**SECTION 00901**

**ADDENDUM NO. 1**

This addendum modifies the Contract Documents dated October 27, 2022, for the San Lorenzo Valley Water District Lyon and Big Steel Zone Pipeline Improvements Project, and the work shall be accomplished in accordance with such modifications. This Addendum includes four (4) pages plus five (5) attachments (total of 29 pages).

Schaaf & Wheeler

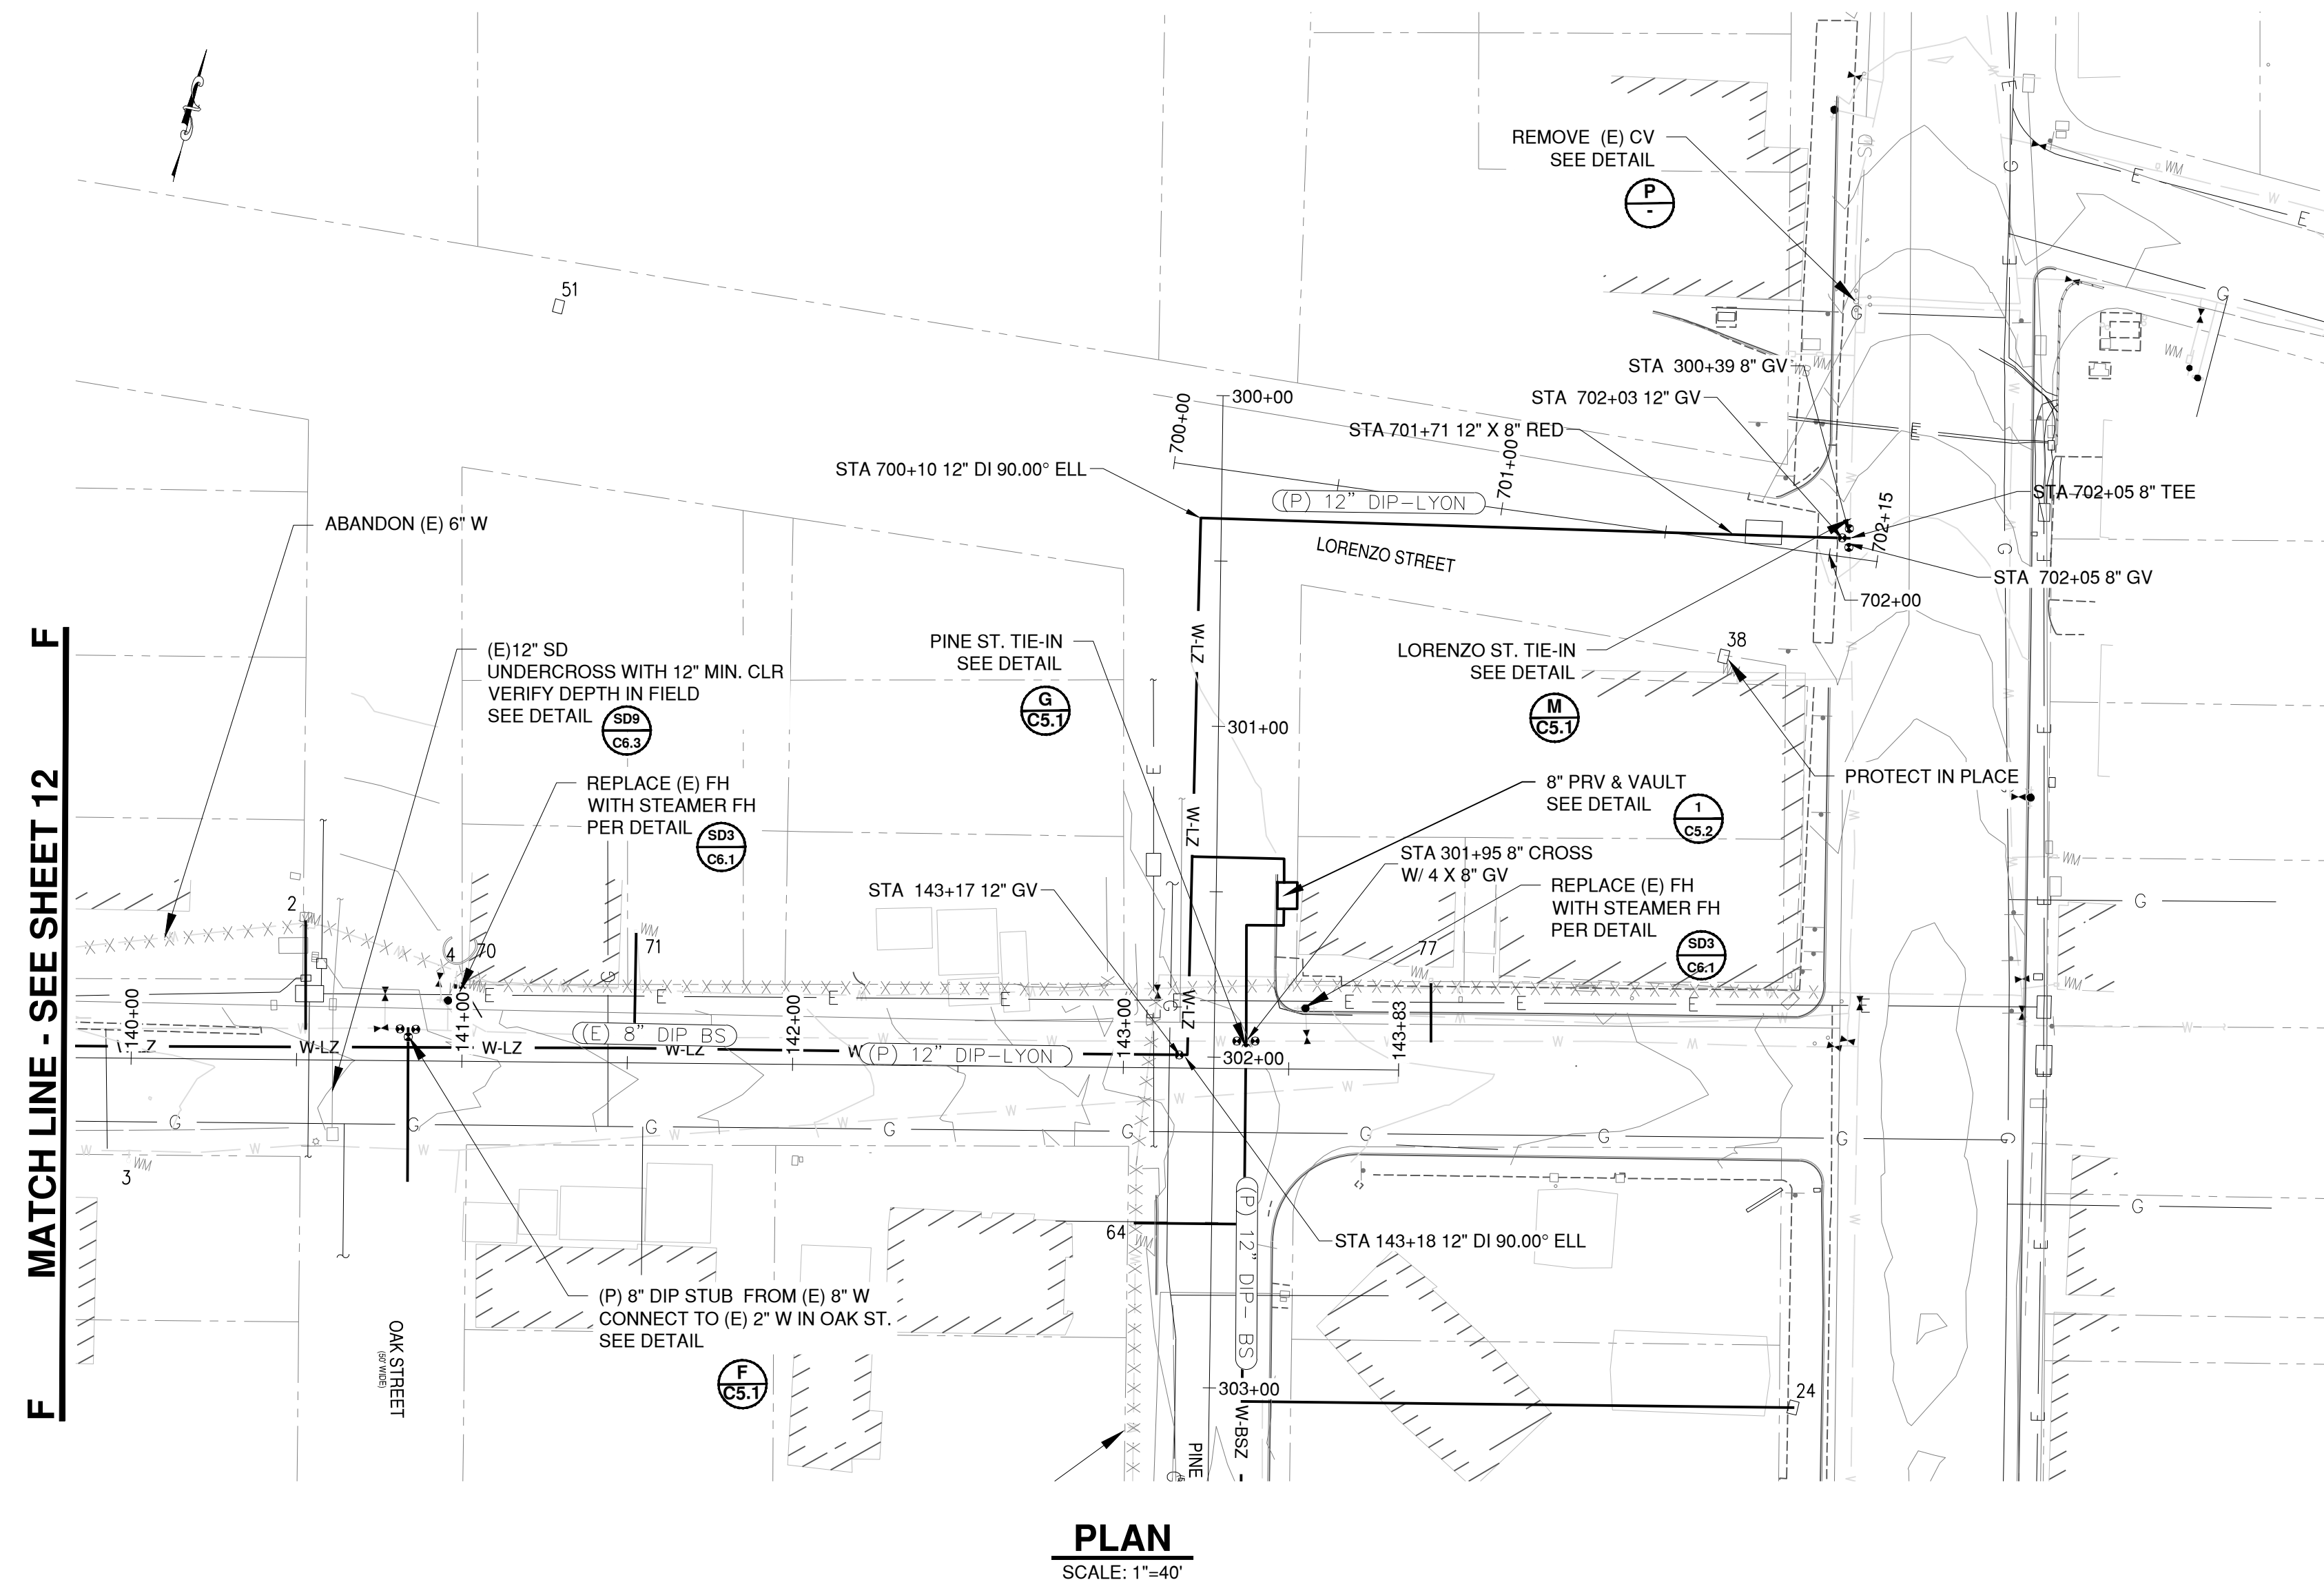
- a. The work in Highway 9 (Main Street) is revised to make the transition simpler. The revised scope is removing the existing check valve, manhole, tees and branch valves and replacing it with a single 8-inch pipe. Decommissioning the rest of the booster pump station will be by District Staff.

"7. Minimum pipe cover shall be 54". When over-crossing other pipelines, the minimum pipe cover shall be 42" within Caltrans ROW, and shall be 36" elsewhere."
- B. Sheet C4.9, Detail P is revised. The changed sheet is attached.
